HISTORIC AND DESIGN REVIEW COMMISSION

May 06, 2015

Agenda Item No: 05

HDRC CASE NO: 2015-131
ADDRESS: 720 N ST MARYS
LEGAL DESCRIPTION: NCB 180 BLK LOT W IRRG 113.2 FT OF 18 ARB 20B
ZONING: D RIO-3
CITY COUNCIL DIST.: 1
APPLICANT: Luna Architecture + Design
OWNER: Dr. Felipe & Gloria Morales
TYPE OF WORK: Exterior modifications
REQUEST:

THIRD FLOOR

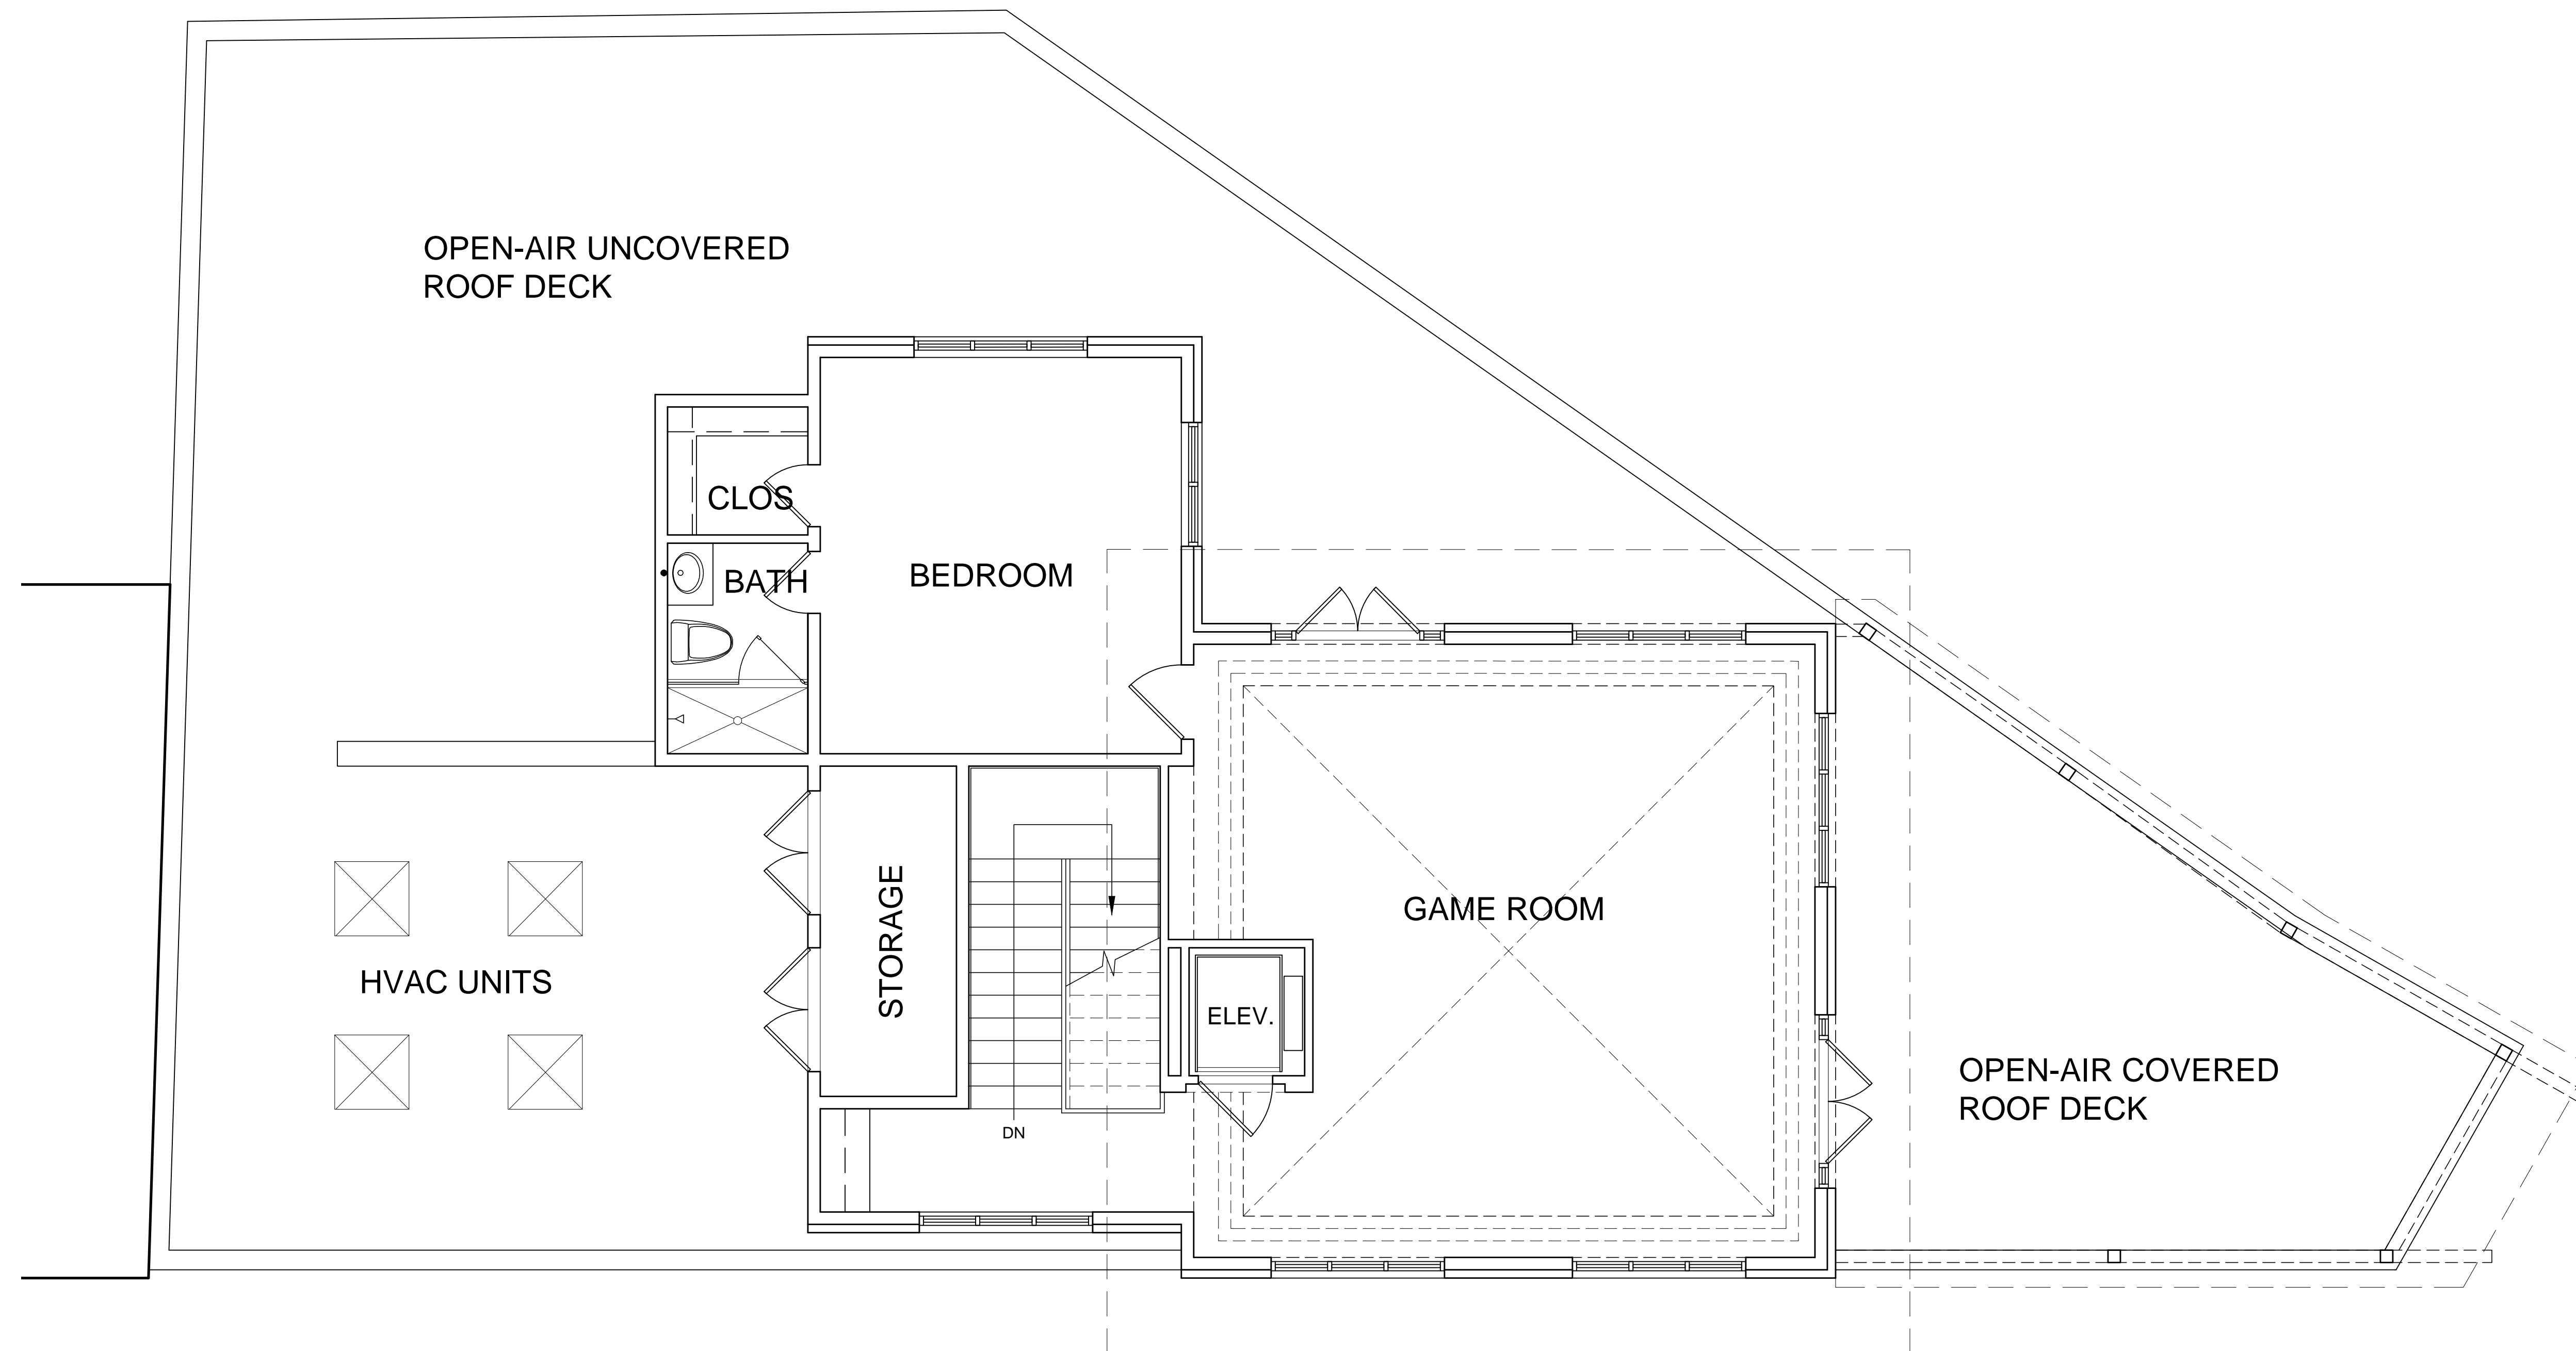
- d. The existing structure features two floors. The applicant has proposed to construct a partial third floor which would include the formation of a tower as well as a covered roof deck. The creation of the tower as well as the partial third floor form a capital and focal point at the roof line to terminate the structure. Staff finds that the creation of the third floor is appropriate, however, there are concerns with the proposed detailing. Staff finds that the third floor additions would be more appropriate with simply detailed railing, simple square punched openings, the elimination of stucco arches and simplistic metal ornamentation.

- i. That the applicant simplify the proposed railing to exclude the curved ornate design, utilize simple, square punched openings, eliminate the proposed arched openings and provide information regarding a final lighting scheme prior to receiving a Certificate of Appropriateness.

RIVER VIEW

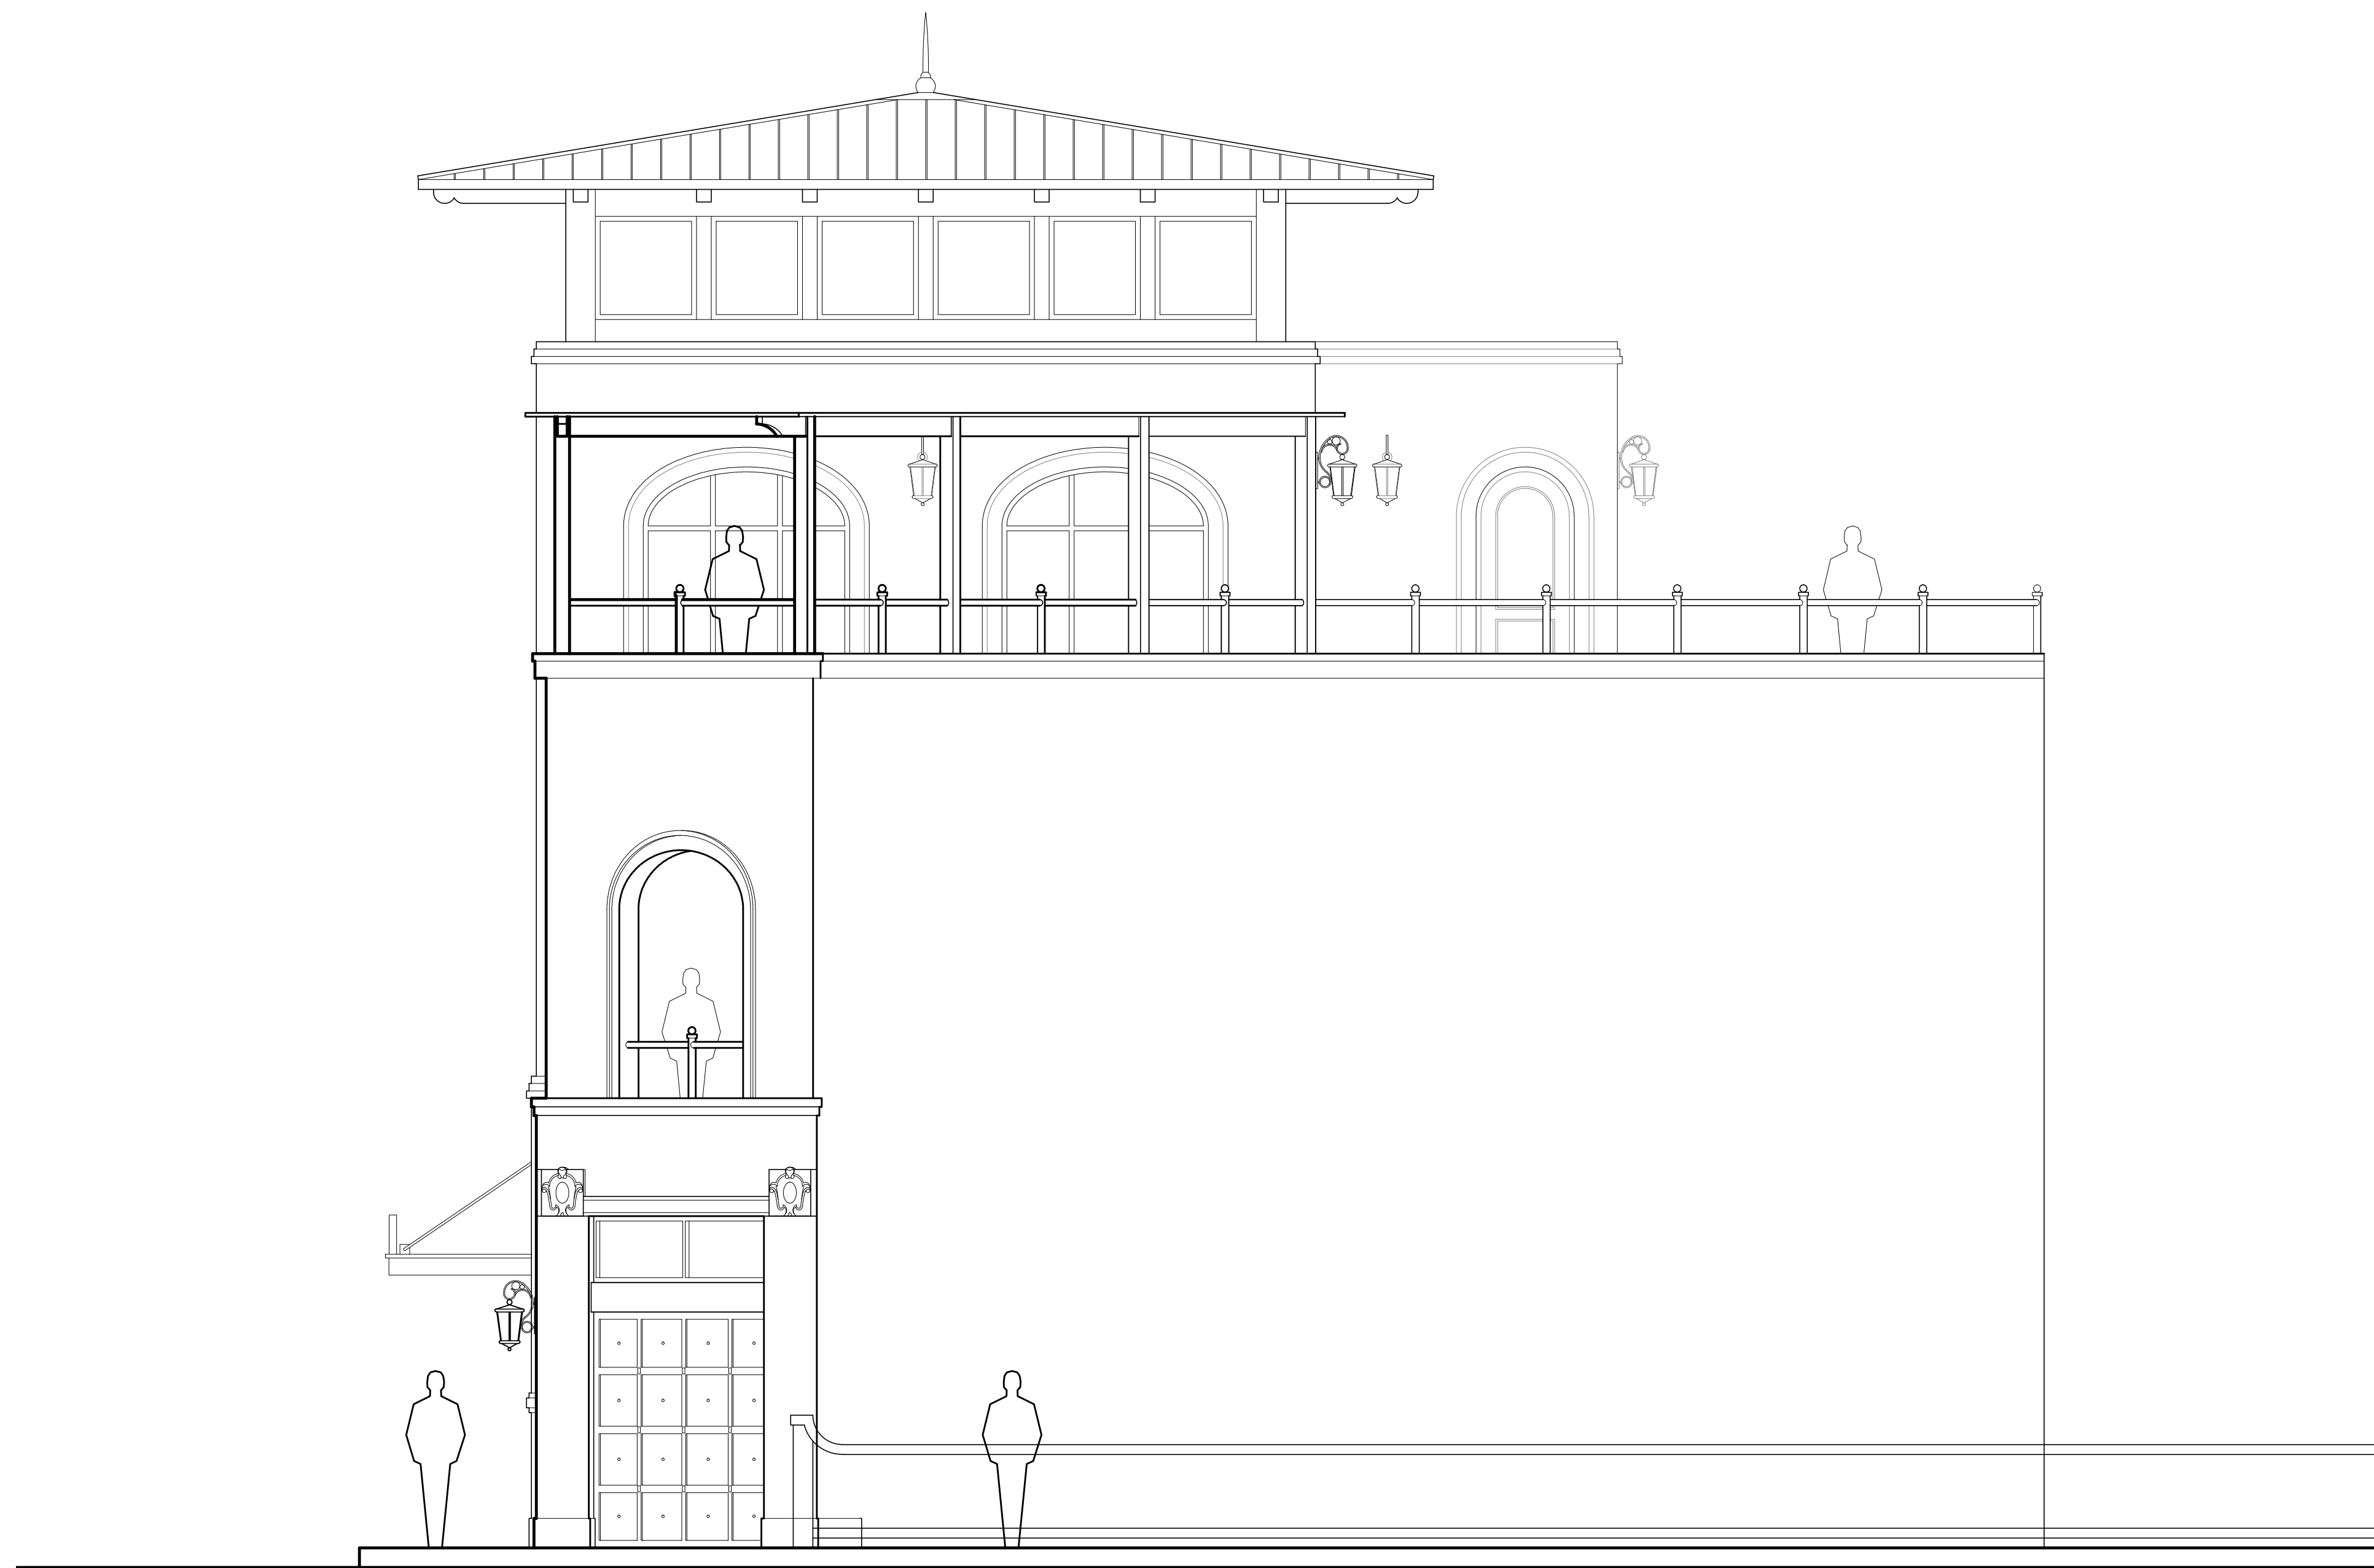
- g. The river side façade currently features balconies that are located at the existing doors and windows. The applicant has proposed to install three foot deep balconies that run the length of both the street level and second level rear facades that face the river. Staff finds the redesign and extension of the existing balconies appropriate and consistent with the UDC in regards to façade composition.

- h. The applicant has proposed to install two open-air terraces on the river façade, one on the first level and one above it on the third level. The footprint of the structure will not change. The proposal to install the open-air terraces creates depth and continues to provide a visual reference for human scale. This is consistent with the UDC Section 35-674(b).
